NATIONAL ENRICHMENT FACILITY

Louisiana Energy Services, L. P.
National Enrichment Facility
NRC Docket No. 70-3103

Subject: Response to NRC Request for Additional Information Regarding National Enrichment Facility Safety Analysis Report and Emergency Plan

Figure ISA-9.1	QUATERNARY FAULTS IN NEW MEXICO
DATE: 5 / 19 / 04

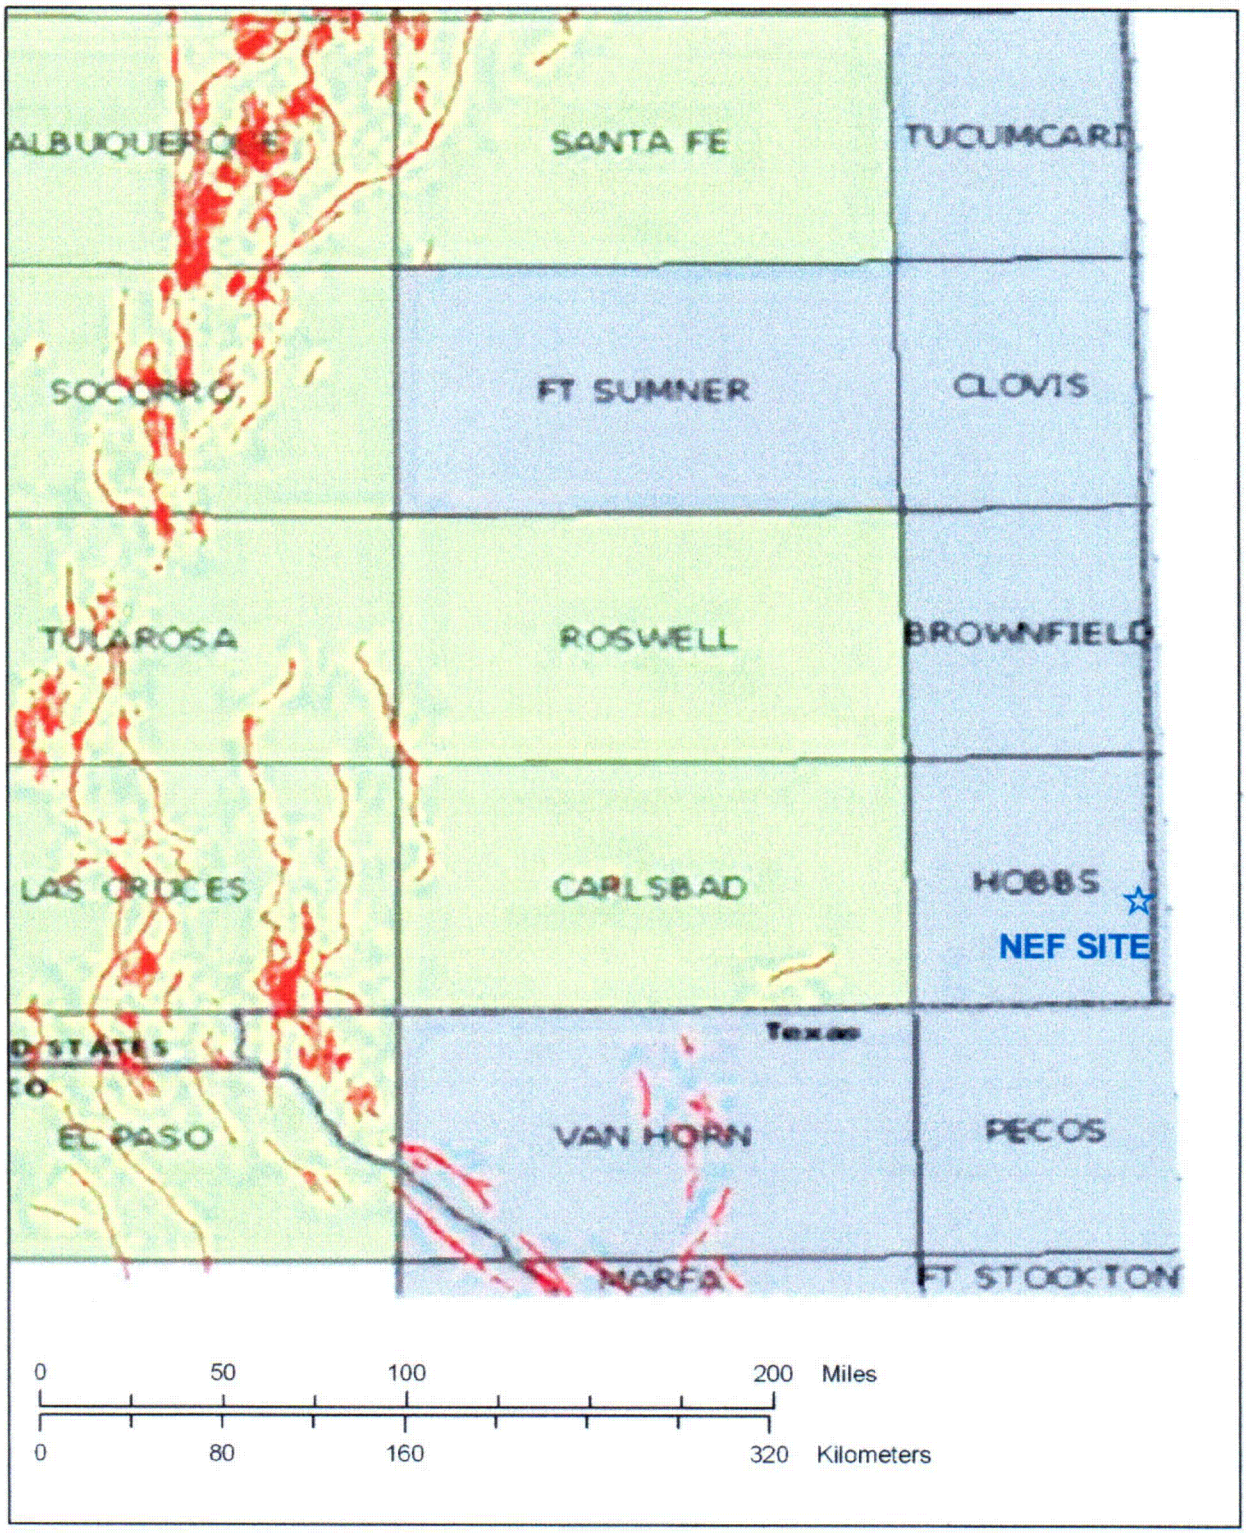
Provide results of investigations conducted to identify any capable faults within a 322-km [200-mi] radius. Page 3.2-23 of the Safety Analysis Report states, "No Quaternary faults are mapped for the site locale. The nearest recent faulting is situated more than 161 km [100 mi] west of the site." It is not clear if any of these faults are capable.

(Note: Figures ISA-9.1 through ISA-9.4 are provided in Attachment 3.) Figure ISA-9.1, Quaternary Faults in New Mexico, and Figure ISA-9.2, Quaternary Faults in Texas, illustrate traces of Quaternary Faults for New Mexico and adjacent areas of west Texas. The Quaternary geologic time period extends from 1.6 million years ago to the present. Other time sub-divisions within the Quaternary include the Late Quaternary that extends from 130,000 years ago to the present, and the Holocene, which includes the most recent 10,000-year time period.

Shown on Figures ISA-9.1 and ISA-9.2 are 1° Latitude by 2° Longitude geographic blocks. The NEF site is located in the Hobbs geographic block. Geographic blocks containing Quaternary faults are color-coded (i.e., non-gray). Figure ISA-9.3, Quaternary Faults Within 322 km (200 mi) of NEF Site, shows geographic blocks for which Quaternary faults are mapped. All of these geographic blocks are located west of the NEF site. Figure ISA-9.4, Locations of Nearest Faults to the NEF Site, shows the Quaternary fault locations detailed in the "Map and data for Quaternary faults and folds in New Mexico, U.S. Geological Survey (USGS) Open-File Report 98-521." The block containing the site, as well as others due north, south, and east of the NEF site has no documented Quaternary faults. Quaternary faults within 322 km (200 mi) of the site are shown on Figure ISA-9.3 using colored and numbered traces, and are plotted over shaded relief topographic maps. The use of topographic relief maps is highly illustrative, because ground deformations resulting from recent fault movements are usually manifested as prominent linear topographic features.
